Re: March 12, 2007 City Council Meeting, Agenda Item 6.C: Supplemental Public  
Comments on the Ambassador West Project by Harvest Rock Church

RE: Response to Memorandum Submitted by Hans Giroux and Robert Silverstein dated February 16, 2007 and Titled "Harvest Rock Church City Response to Comments"

# PARCEL EXHIBIT

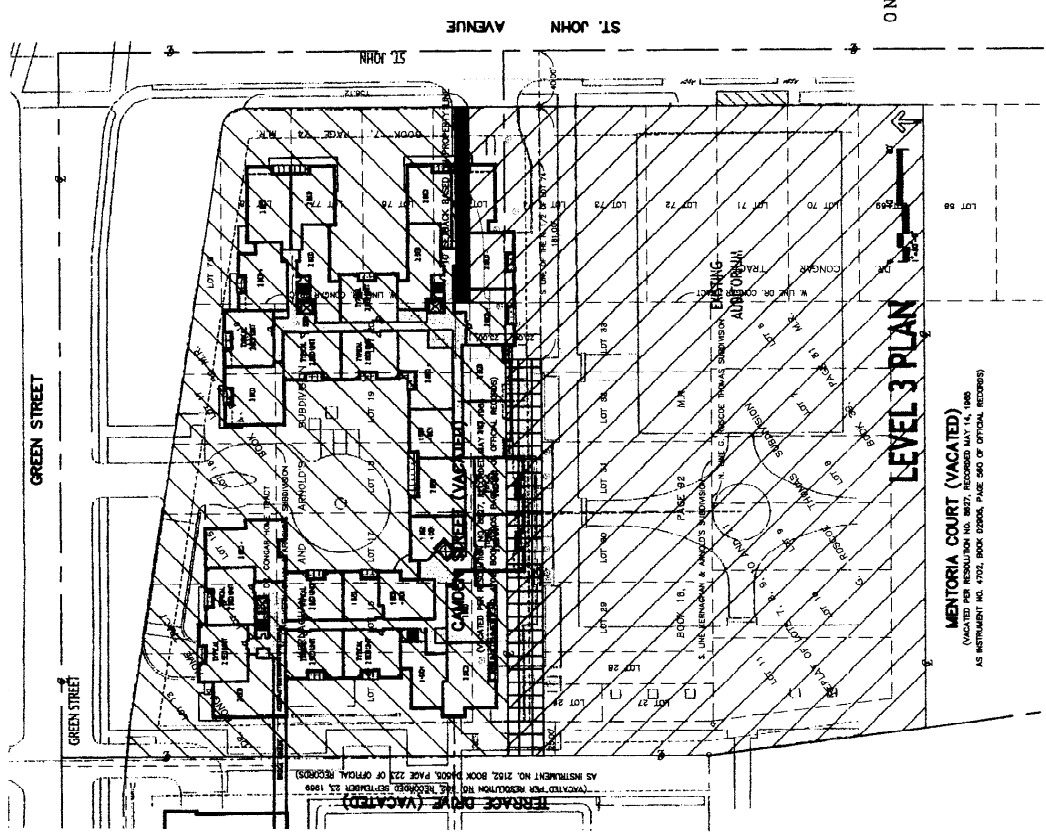
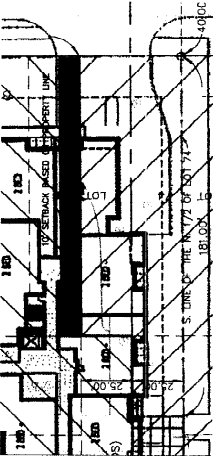
Because the Project intends to construct approximately 18 condominium units, the loading dock, and parking entrance on HRC's property, as well as construct an unknown number of parking spaces below HRC's property (see Exhibit 1 hereto), the Project description in the FEIR is fatally flawed, and on that additional basis, the FEIR cannot be approved.

The project applicant proposes to build a loading dock, parking access, the parking entrance, and approximately 18 residential units on land that belongs to HRC, not including portions of other units partly on HRC's property. (See Exhibit 1.)

Moreover, because the Project as proposed cannot go forward, the Project description in the DEIR and FEIR must be corrected. A finite project description is the *sine qua non* of an adequate EIR under CEQA. Here, the Project description must change to reflect the correction of excluding the portions of the Project shown in Exhibit 1 which are currently on HRC's property.

The City cannot approve the Vesting Tentative Tract Map because the proposed subdivision of property includes property owned by HRC. (Exhibit 1.) Pursuant to Government Code Section 66474, the City cannot approve the Vesting Tentative Tract Map as a result of at least the following [see in particular the bolded sections]:
